Access Compliance Report Public Rights-of-Way (Curb Ramps)

Main Street: PACIFIC_AVE Cross Street: CREW_DR Location: NW

ADA ID: RPRK210922125641 Ramp Type: Type 1 - Perpendicular Diagonal Initial Pass/Fail: Fail Overall Compliance: No Severity Score: 30

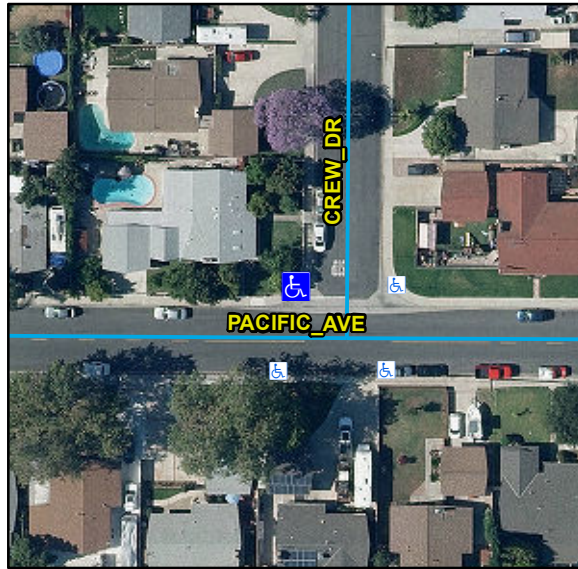
R304.2.2, R302.7.2, STD 1115

Remove & Replace Curb Ramp With Two New Directional Ramps or Equivalent. Grind Gutter Lip.
